Manual Change Information

# TM-1010PN

Since some details of the TM-1010PN service manual (No.51180, Jan. 1997) were changed, we are informing you of these changes and of the new descriptions.

SIGNAL PW BOARD CIRCUIT DIAGRAM(Page 2-8)

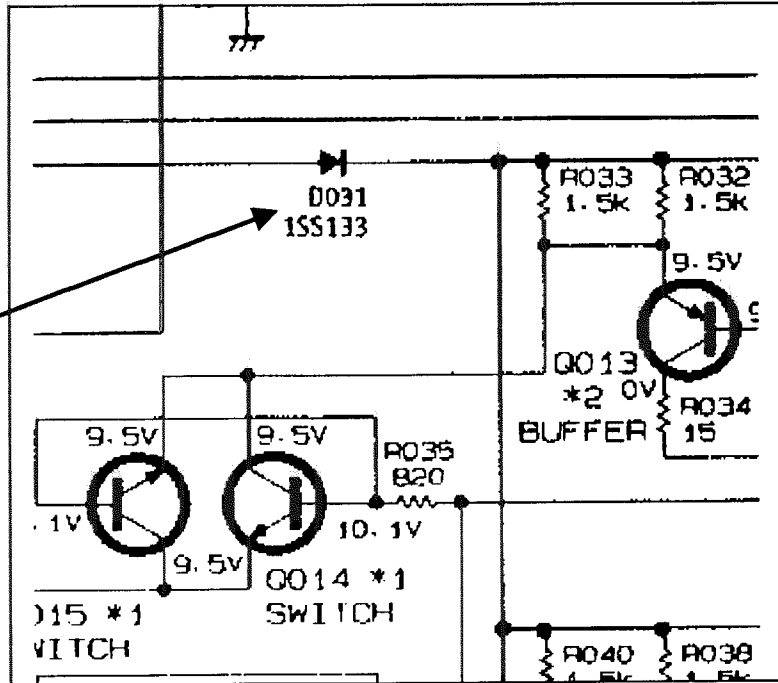
The circuit has been changed as follows in order to accommodate the DVD copy guard.

△	SYMBOL No.	PARTS No.		PARTS NAME	DESCRIPTION
		PREVIOUS	NEW		
△		FX-1089A	<b>FX-1089B</b>	SIGNAL PWB A'SSY	
	D031 (D1031)	1SS133-T2	1SS353-X	SI. DIODE	
	R875 (R1875)	----	QRSA08J-473YL	CH MG RESISTOR	47KΩ
	R876 (R1876)	----	QRSA08J-104YL	CH MG RESISTOR	100KΩ
	R877 (R1877)	----	QRSA08J-102YL	CH MG RESISTOR	1KΩ
	C823 (C1823)	----	NCT03CH-102AY	CHIP CAPACITOR	0.001μF 50V

PREVIOUS  
(FX-1089A)  
1SS133-T2

NEW  
(FX-1089B)  
1SS353-X
